NEW Enter & Exit Door

Centerline Dimension From 7" to 5"

Inspect, Confirm
ONLY Concrete Pit
NEW Enter & Exit Door Centerline
From 7" to 5"

NEW ENTER & EXIT DOOR CENTERLINE

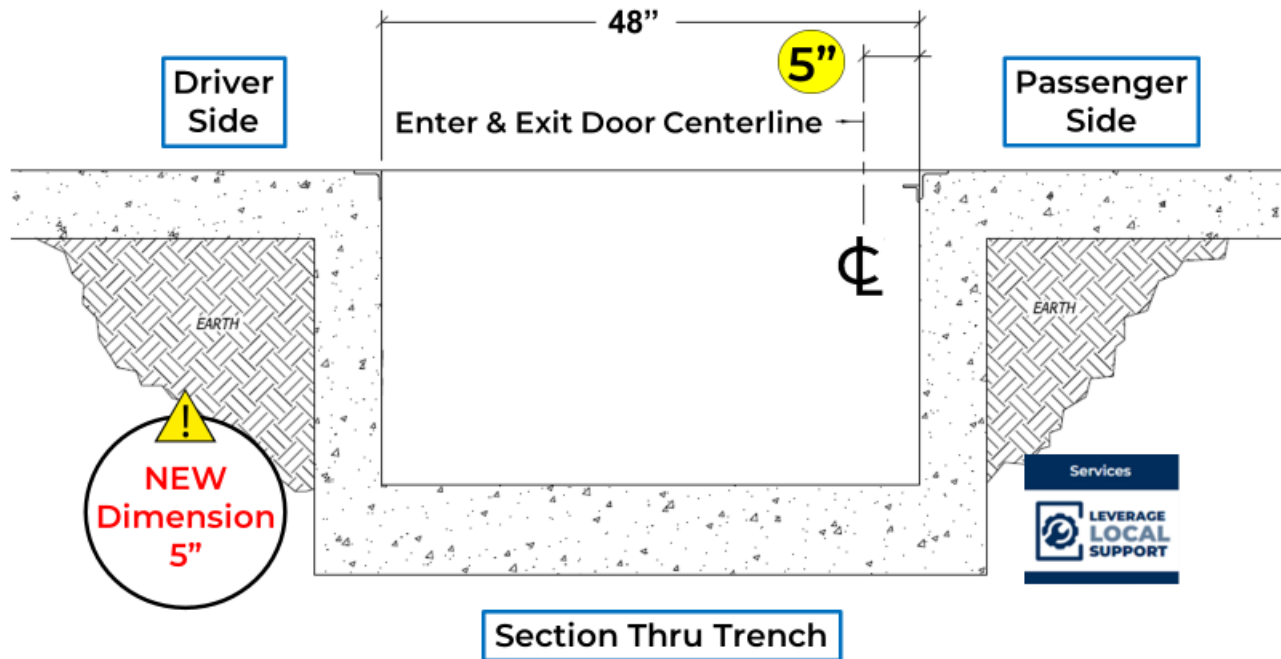
As of August 1, 2022, the Enter and Exit Door Centerline Dimension will change from 7" to 5". The change reflects the position of the Trench in Relation to the Door Centerline.

**IMPORTANT:** This DOES NOT affect installation it ONLY affects the pit location during site construction.
